# CERTIFICATE OF APPROPRIATENESS PLACARD

549 N BLOUNT STREET

- Renew and change COA 076-10-CA for rear parking area.
- Change layout, surface material and add new walkway.

Holy Trinity Church Parking Lot COA Renewal

PROPOSED SITE Landscaping

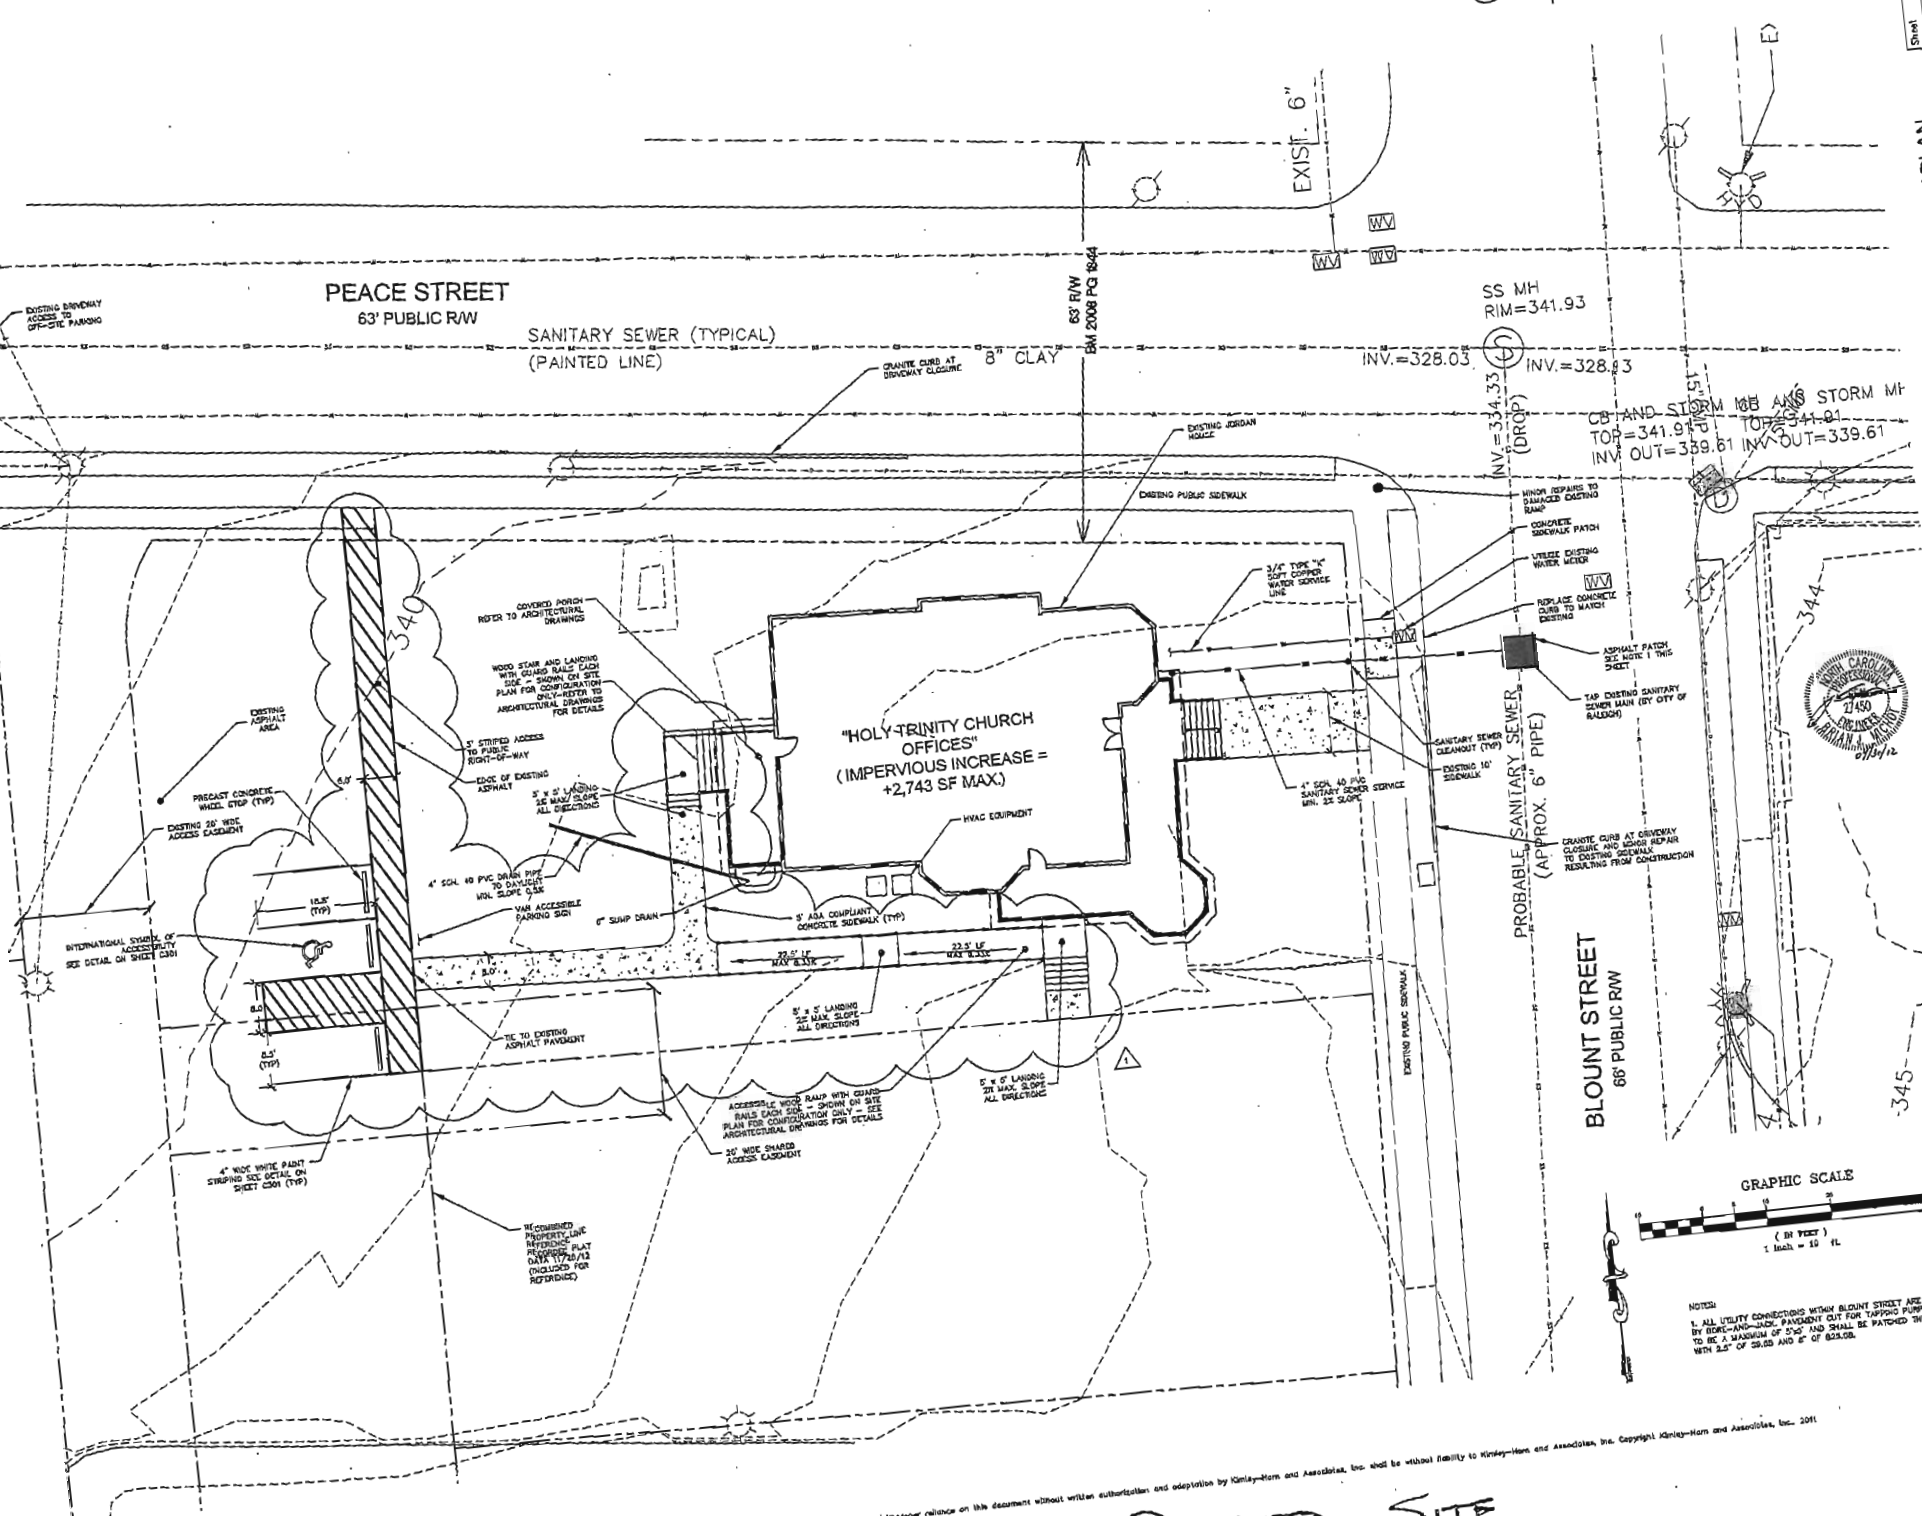
I am reviewing your COA application for the parking lot at 549 N Blount Street and need additional information. In looking at the lot that was approved in 2010 (COA 076-10-CA) the layout has changed. Additionally there are walkway changes that do not show up in any of the approved COAs.

- Gravel surface rather than asphalt for the parking lot;
- New walk between the parking lot and house that extends to the city sidewalk on Peace Street;
- Layout of the parking area (I’ve attached the application from 076-10-CA);

- The tree protection plan as required by 076-10-CA;
- Electronic versions of the drawings provided in the application (they are hard to read as printed);
- Parking lot edge treatment;
- Clarification on the location of the new walk. The drawings provided do not show the stairs on the rear of the house.

The drawings show tree protection fencing, but that is only part of a tree protection plan. We also need to know what care will be taken during the installation of the surrounding sidewalk and parking area to avoid killing the tree. The critical root zone expands far beyond the proposed tree fencing. Typical measures include hand digging in the critical root zone. Of specific concern to your tree is the continuous concrete footing for the perimeter of the parking lot.

Thanks for pointing out a design issue at the stairs. We have a solution. It was merely an oversight with regards to the civil engineer not picking up everything from the architect.

I have attached a digital plan that should encompass all of the clarifications that you were requesting.

I can't remember the sequencing of permitting but as part of the site plan review for the Trinity House building permits, the zoning folks enforced a new ordinance within the City. It requires that all structures on corner lots must have walkways leading to both street frontages. In the context of design of the Trinity House and the new Handicap ramp, it made more sense to have the walkway to Peace street in the rear of the house. We simply left some existing asphalt to make that one walk path that was utilized until now. The attached plans memorialize what our long term intent was to be with regard to pedestrian access. Hopefully that helps explain the back and forth a bit.
